SEWAGE DISPOSAL SYSTEM

MARYLAND STATE DEPARTMENT OF HEALTH

HOWARD COUNTY

SUBDIVISION _____ ROAD 10126 Stansfield Rd. LOT _____

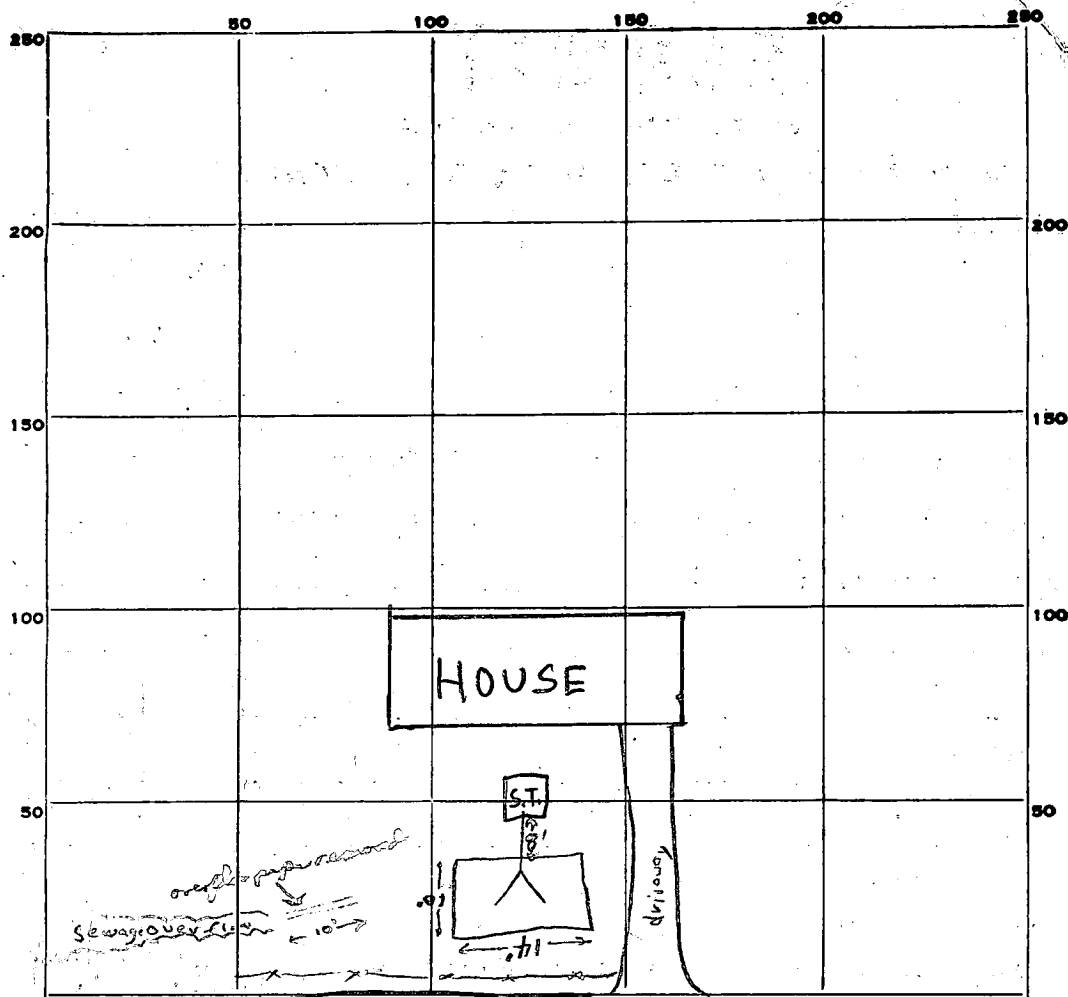
OTHER Recommend leaching bed ~~XXXXXX~~ around 16 ft. x around 20 ft. with at least 3 ft. of gravel under distribution pipe. Stay 4 ft. above water table with bottom of leaching bed. Have one hole or one end of leaching bed dug open to 13 ft. to check soil type and water level (inspector will check on site) cover no work until inspected and ~~approved~~ approved.

REMARKS 11/16/77 Old leaching bed exposed; gravel depth 1½-2' but upper 1ft of gravel is dry, appears that overflow pipe at roadside ditch was diverting sewage flow, O.K. to clean out loose earth in pit and install new sewer pipe and distribution pipe & gravel to slightly higher elevation, so that old leach bed can still be used, also removed and seal off old overflow pipe so that overflow cannot occur F.S., 11/16/77 O.K. to cover all work F.S.
